PLANNING PROPOSAL (AMENDED)

601 Pacific Highway,
St Leonards

STOCKLAND DEVELOPMENT PTY LTD

29 September 2023

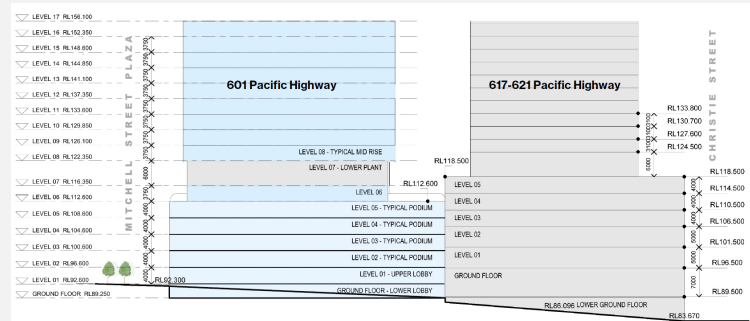
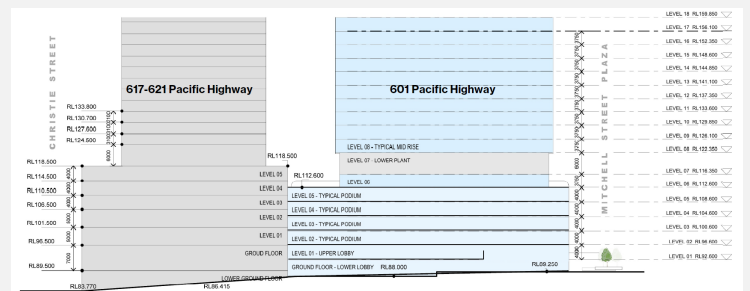
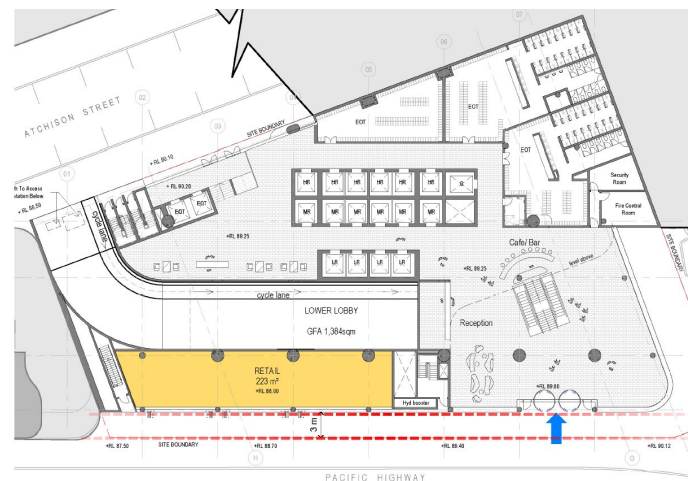
<h3>2.3 Podium Heights</h3>	
<p><i>The indicative built form includes a 6 storey podium height fronting Pacific Highway, and a 5 storey podium height fronting Atchison Street, which does not comply with the 2036 Plan and the NSDCP 2013.</i></p> <p><i>Within the same block, the 617-621 Pacific Highway site is adjacent to the subject site to the west, which has a 6 storey podium height control fronting Pacific Highway under the NSDCP 2013. The maximum existing ground level difference between the two sites along Pacific Highway is 7m, which is equivalent to approximately 2 storeys. As this block only contains these two sites, and Pacific Highway is a major street frontage, it is important to have a consistent podium height for this block to provide a good contextual response along Pacific Highway.</i></p> <p><i>It is recommended that a 4 storey podium height is applied to Atchison Street, Mitchell</i></p>	<p>The 2036 Plan incorporates specific built form parameters for the subject site that have been informed by detailed urban design analysis. It is considered that the built form parameters of the 2036 Plan prevail to the extent of any inconsistency with the DCP 2013 particularly given the terms of the Section 9.1 Ministerial Direction.</p> <p>The indicative concept proposal has been designed to achieve compliance with the 2036 Plan podium street wall heights controls. However, the site's topographical conditions do not allow strict compliance with the five storey street wall height. The varied podium height is a direct response to the gradient, which falls from the north-east by 2.5 metres to the south and 3.5 metres to the west. This is long accepted urban design response to site conditions.</p> <p>Notwithstanding the minor variance, at the site's most visible and prominent frontage to the intersection of Atchison Street and Mitchell Street, the podium expression establishes a five storey street wall height. This is consistent with the 2036 Plan and establishes a consistent podium datum line that aligns to the prevailing streetscape in the surrounding locality.</p> <p>The Pre-Lodgement Meeting Response Report includes the following elevations to indicate that the indicative concept proposal achieves an</p>

Plaza and the majority of the Pacific Highway frontages. Where the site is adjacent to 617-621 Pacific Highway, a 5 storey podium height can be considered to address the site level difference. In addition, the proposed podium height should reflect general floor to floor height to avoid an oversized podium.

appropriate contextual response in terms of podium datum lines along the Pacific Highway and to the Atchison Street frontage.

Ground Floor Plan

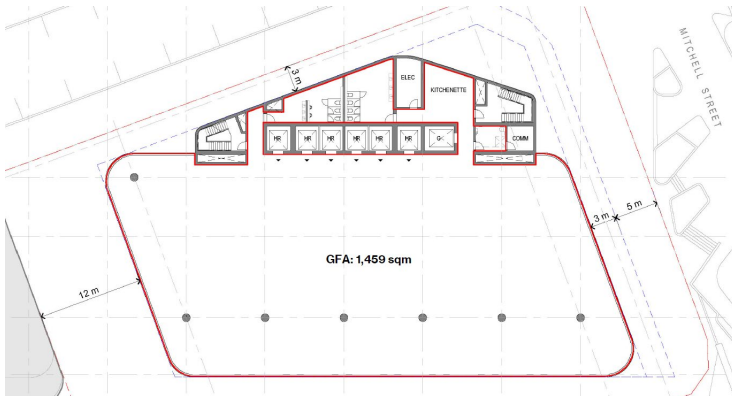
The proposal provides a mix of 3m and 0m setbacks at ground level to the Pacific Highway, which does not comply with the 2036 Plan and the NSDCP 2013. The 3m setback is consistently applied along the Pacific Highway and adherence to this is required in future documentation. This will provide a better pedestrian experience along this stretch of the Pacific Highway. Colonnades should also be avoided in this zone to create a barrier free pedestrian environment.

The ground floor setback along Pacific Highway to comply with the minimum requirements in the 2036 Plan and NSDCP 2013.

The indicative concept proposal has been modified to comply with the setback requirements of the 2036 Plan and DCP. The lower ground floor has been revised by removing all podium architectural features, hydrant booster value, and the columns from the 3m setback zone. These revisions provide a more generous and continuous footpath along the Pacific Highway. They also provide continuous weather protection and amenity along this portion of the Pacific Highway which overall results in a superior outcome and more friendly pedestrian experience along the Pacific Highway. The Pre-Lodgement Meeting Response Report contains the revised ground floor plan, as below.

<p>2.8 Mitchell Street Plaza</p> <p><i>According to the landscape ground level plan, the proposal does not include any</i></p>	<p>The introduction of trees is envisaged in order to create "green streets" as envisaged in the 2036 Plan. Council has encouraged densifying</p>

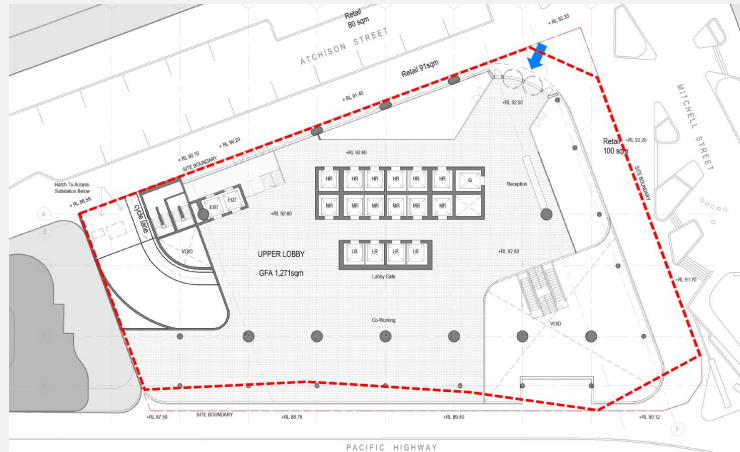
street trees in the setback zone along Mitchell Street Plaza. Instead, the setback zone incorporates hard paving.

In addition, the proposed basement levels are built to the boundary along Mitchell Plaza without a 5m setback. This arrangement will limit the opportunities for street trees in the setback zone.

Tree lined linear parks along Mitchell Street and Mitchell Plaza are important features of the 2036 Plan. The basement levels are required to be located beneath the building footprint to allow for adequate deep soil zones.

biophilia in the Mitchell Street Plaza, in particular on the western side of the subject site (601 Pacific Highway) frontage through the introduction of deep soil planting in the 5m setback zone.

The indicative concept proposal retains the existing car park structure. The Pre-Lodgement Meeting Response Report includes a diagram to illustrate the extent of the existing car park compared with the site area. This area does not allow sufficient area for deep soil planting therefore alternative landscape solutions are considered.

The proposal has been revised to accommodate trees along Mitchell Street Plaza to promote a “greener” space. This design revision provides shade, amenity, and a more aesthetically pleasant urban environment for pedestrians. However, it is not possible to promote deep soil planting on Mitchell Street Plaza frontage due to the existing basement structure which is to be retained. The Pre-Lodgement Meeting Response Report includes the diagram to depict options for new planting along Mitchell Street Plaza in pots or planters.
